Type Coffee Vending Machine	Model 9100	N° T.I. 02 - 2020
Serial Number 94511620	Subject NON-RETURN VALVE INTEGRATED with BY-PASS	ISSUED FOR (X) Action Information <input checked="" type="checkbox"/>

REASON:

Be informed that with the aim to improve and standardize our equipment

New **"non-Return Valve + BY-PASS"** integrated
Spare code: **257729 sap: 55120060**

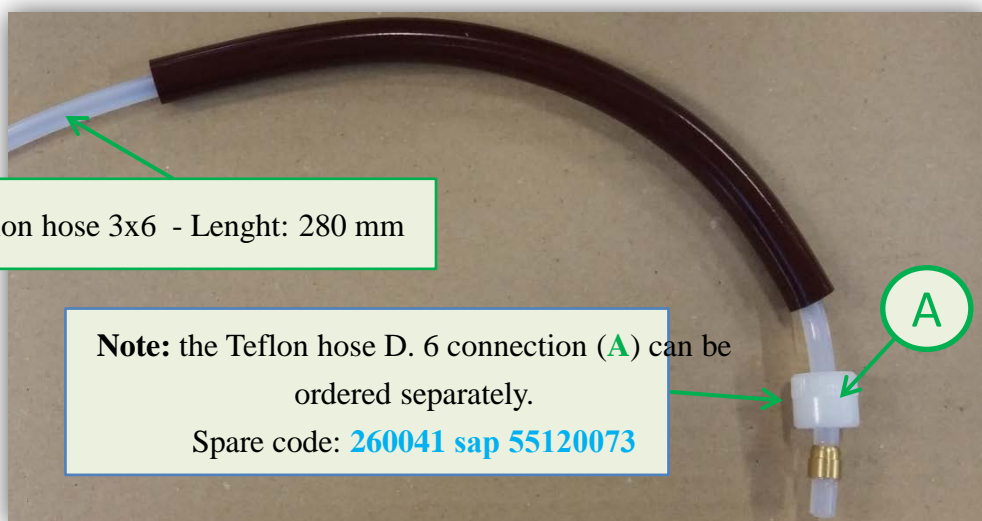
A **new non-return valve**, integrated with a **by-pass**, has been introduced. The new valve is made of polyamide.

New solution
Non-Return Valve + BY-PASS integrated

Pre-modification solution
Non-Return Valve + BY-PASS separated

➤ **Machines concerned by modification from S/N 94511620**

New **hose assembly** for *non-return valve* - Spare code: **262051** sap: **55121774**

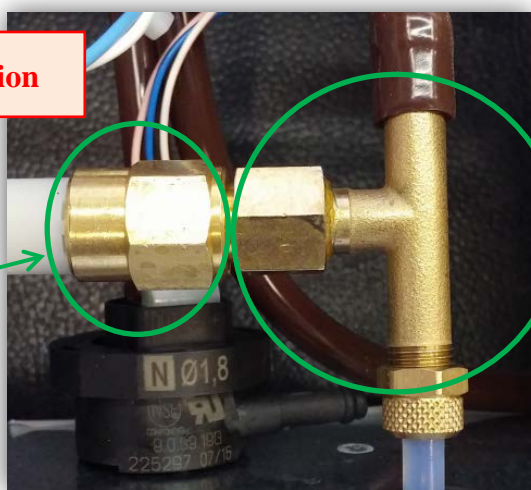
Important note: for machines prior to above S/N, it's possible to implement the **"Non-Return Valve + BY-PASS integrated"** by ordering the **hose assembly (1)** and the **OR gasket (2)**.

Teflon hose 3x6 - Length: 280 mm

Note: the Teflon hose D. 6 connection (A) can be ordered separately.
Spare code: **260041** sap **55120073**

2 : Gasket OR 1,5 x 5,5 Spare code: **260042** sap **55120061**
